DEPARTMENT OF WATER RESOURCES

SCH# 2020069036, Notice of Preparation and Initial Study (NOP/IS) for the United States Cold Storage Hesperia in San Bernardino County

The California Department of Water Resources (DWR) Division of Operations and Maintenance (O&M) staff has reviewed the City of Hesperia's (City) NOP/IS for the proposed United States Cold Storage Hesperia project and has the following comments.

Map of project location, site plan, and State Water Project (SWP)

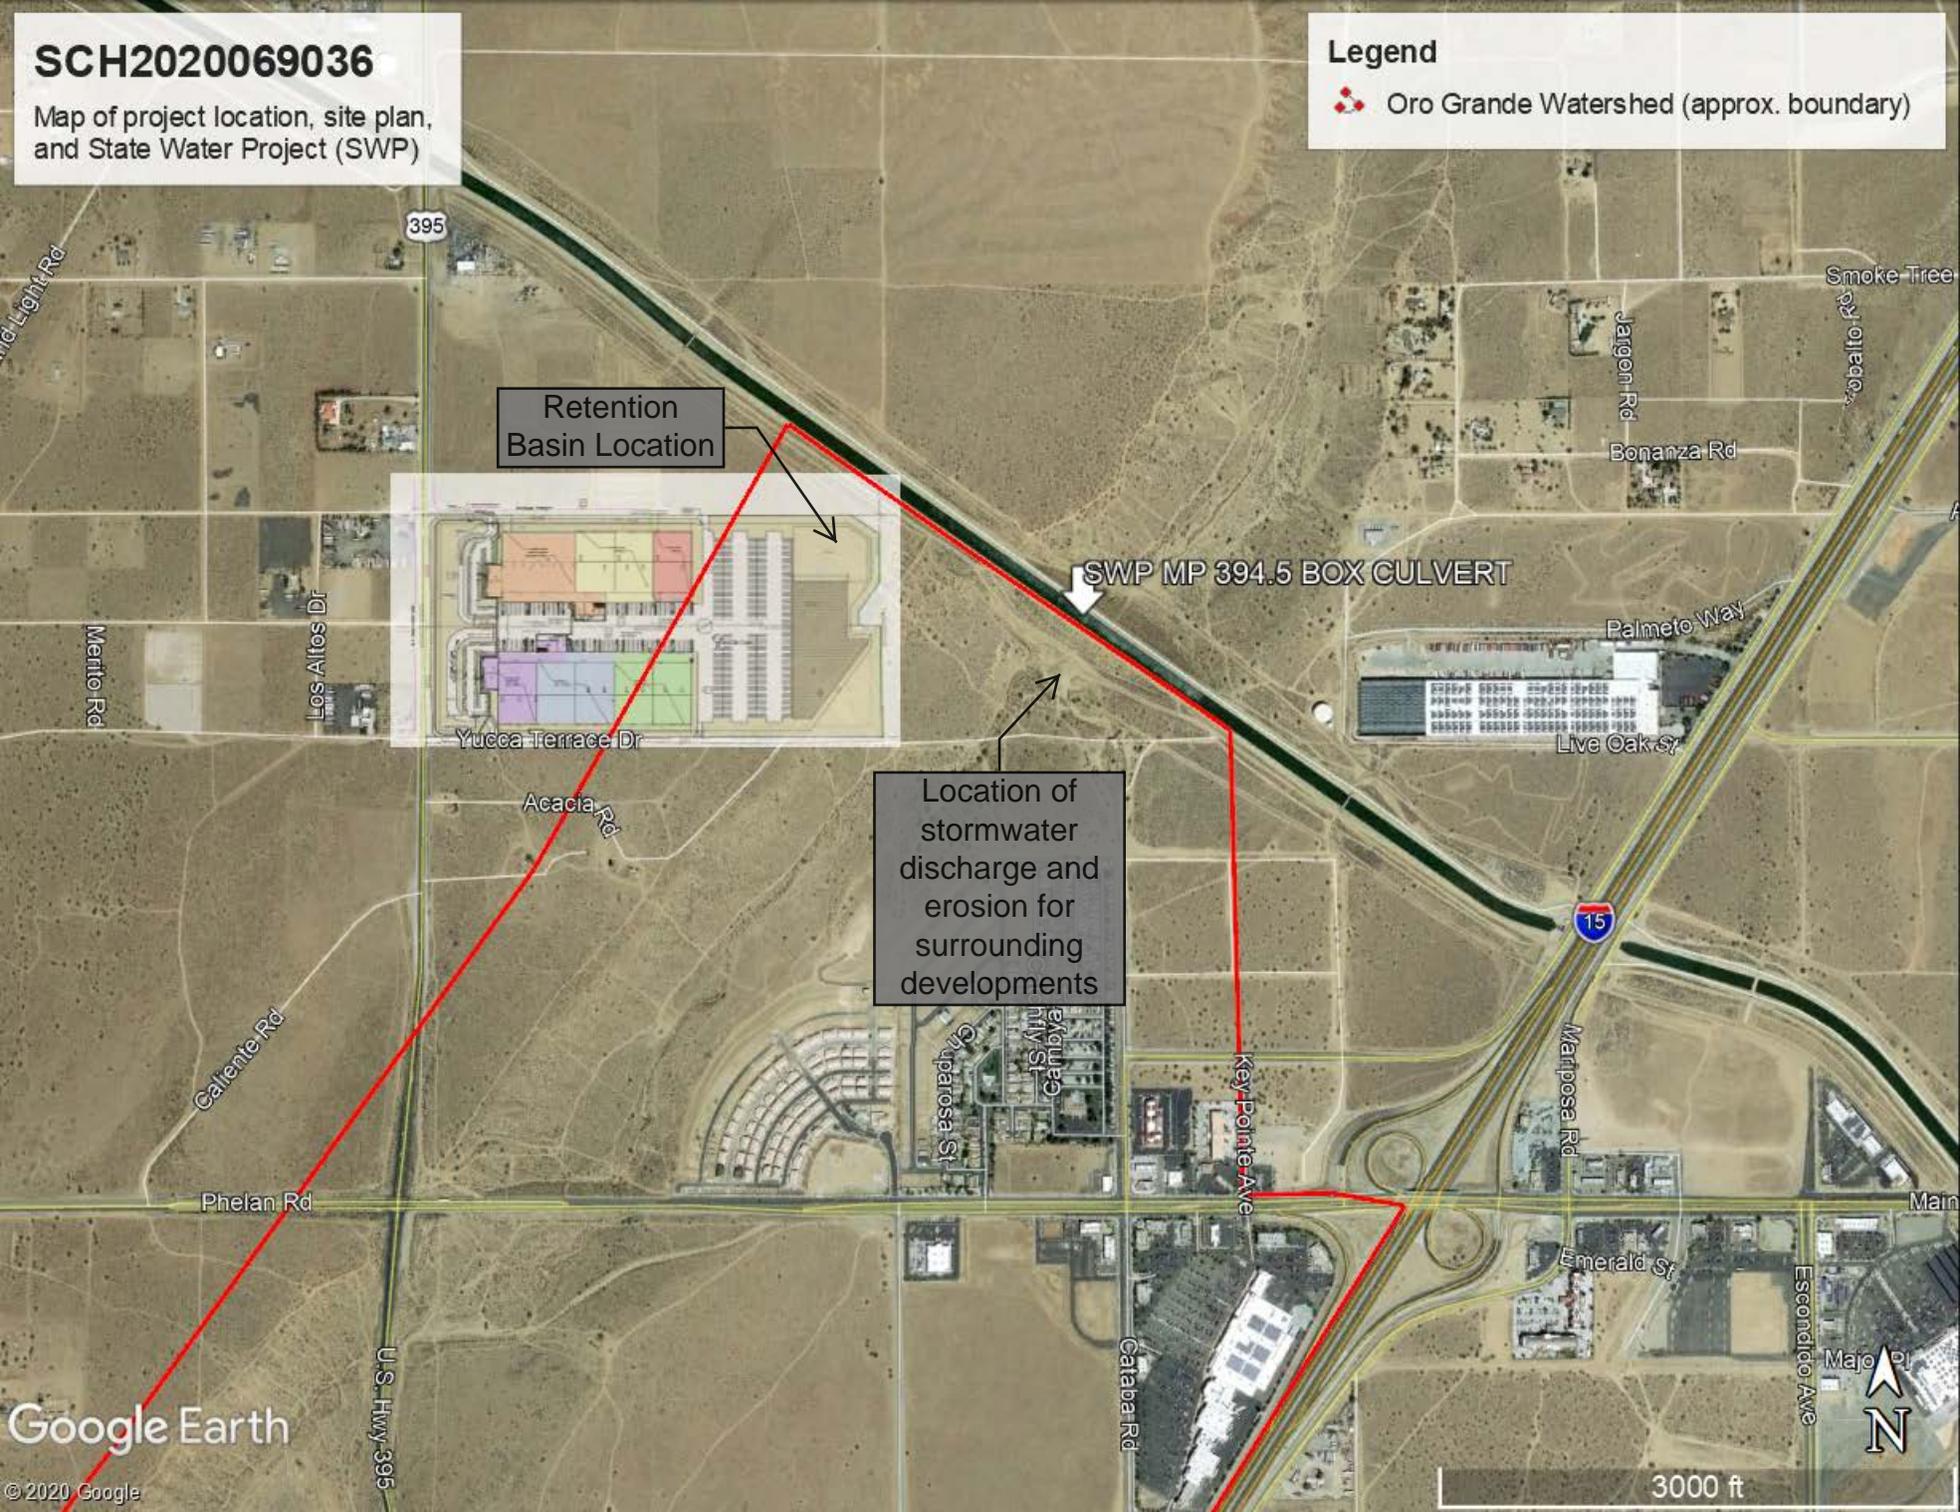
Please add to the description and the vicinity figure the location of: the Oro Grande Watershed boundaries; the Wash channel; the California Aqueduct; the proposed project's retention basin, and the location of all existing retention basins and stormwater discharge locations in the proposed project region. To assist you, attached is a map of facilities we have located in the project area which we request be included in the project overview. (attachment 1).

Based on the preliminary project drawings in the IS, the project may direct storm water discharges from the proposed retention basin, along the mesa on the west side of the Wash and down into the Wash near the DWR culvert under the California Aqueduct at Milepost 394.5. This may impact the functioning of the California Aqueduct. Of particular concern is the elevation change between the proposed detention basin down to the inlet of the DWR culvert, which is approximately 80 feet, based on Google Earth imagery.
